PLAN-009105

Proposal: Two storey side extension.
Site: 33 Elm Grove, Barnham, PO22 0HL.
EG/14/15/HH

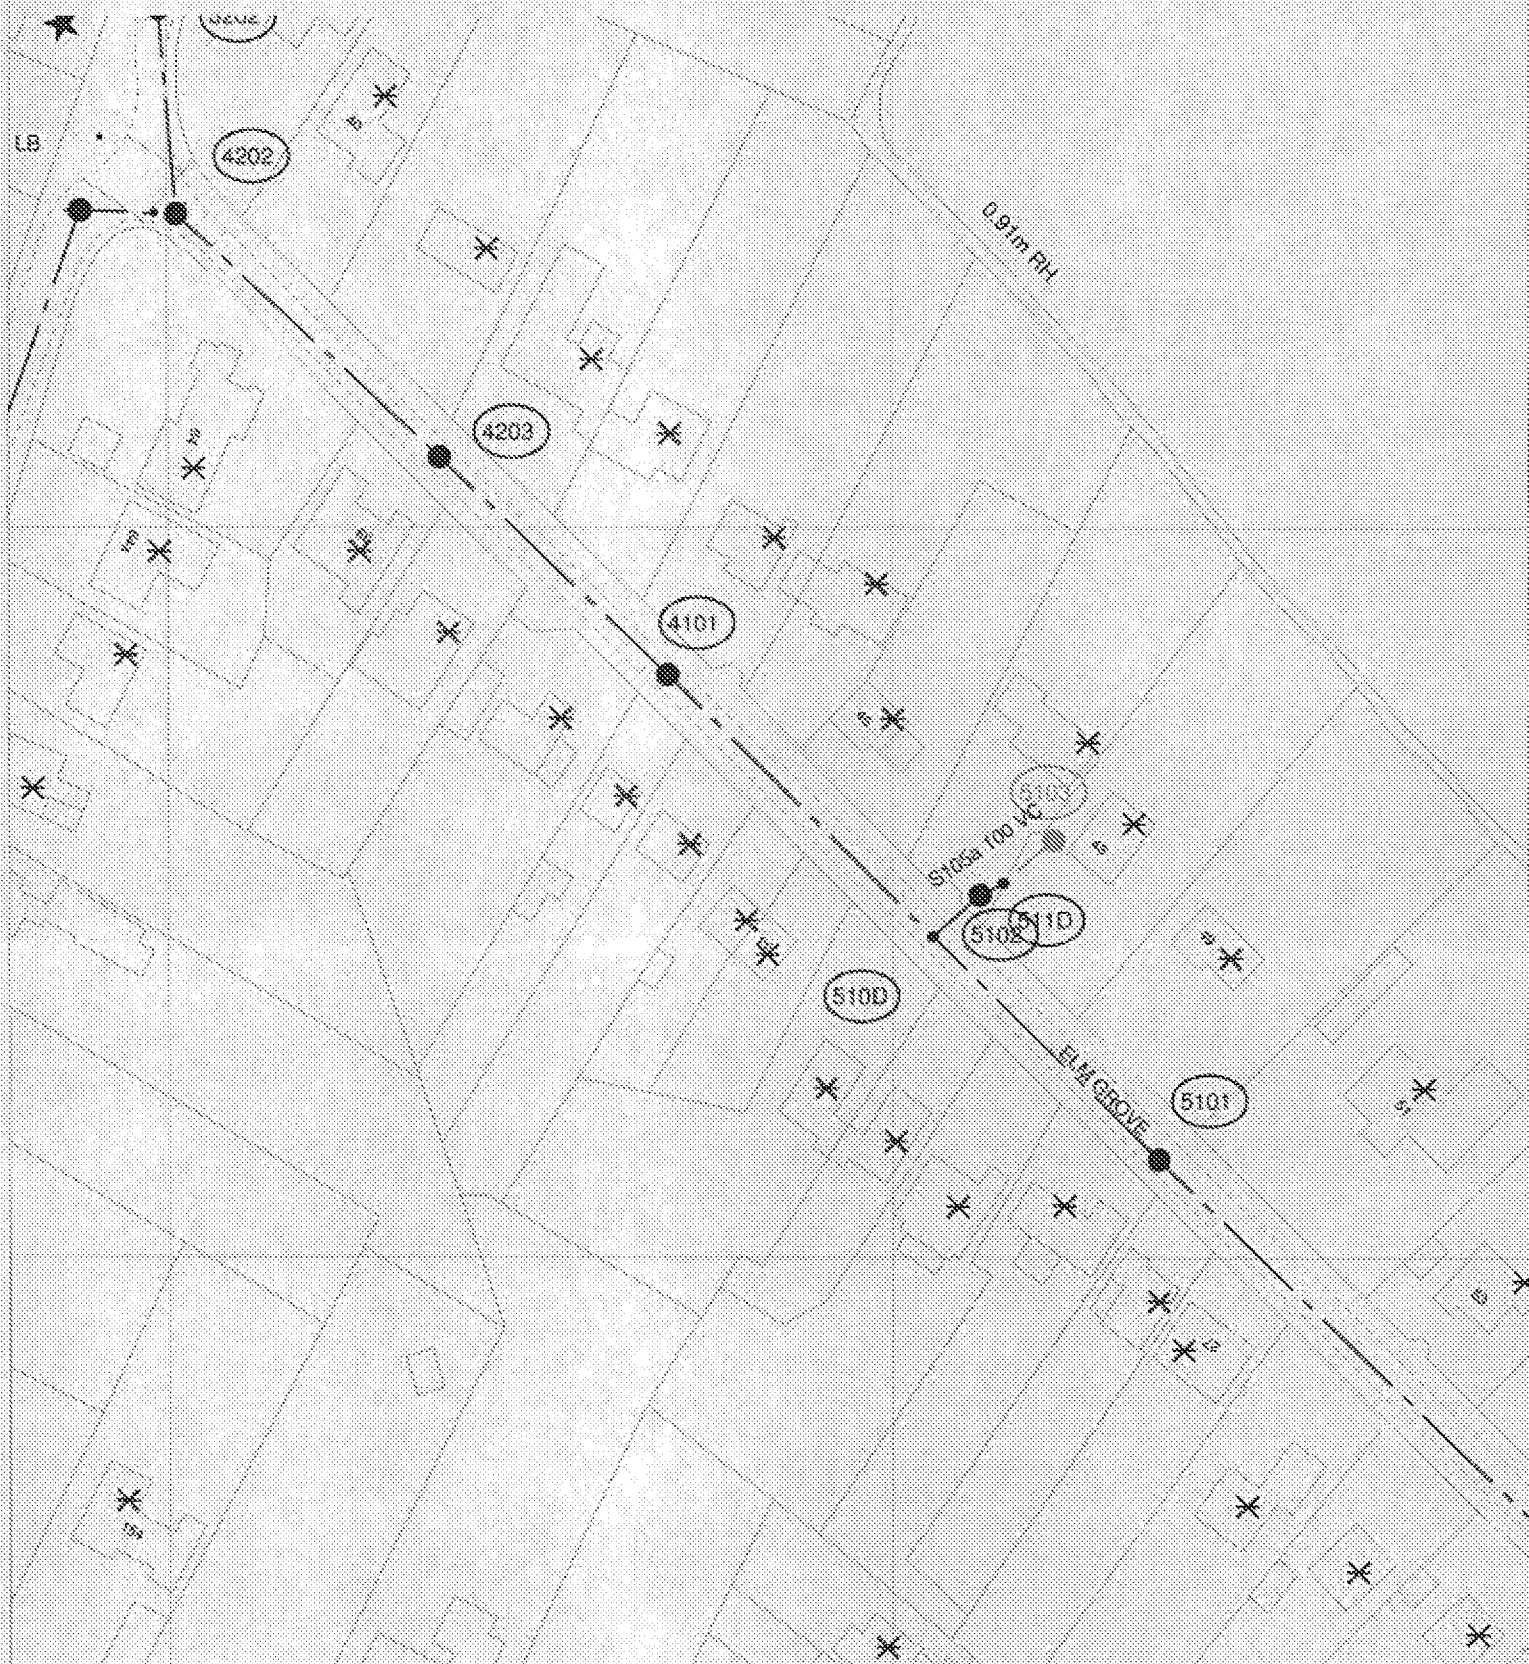
The positions of pipes shown on this plan are believed to be correct, but Southern Water Services Ltd accepts no responsibility in the event of inaccuracy. The actual positions should be determined on site.

WARNING: BAC pipes are constructed of Bonded Asbestos Cement

WARNING: Disks seen (UNK) materials may include Bonded Asbestos Cement
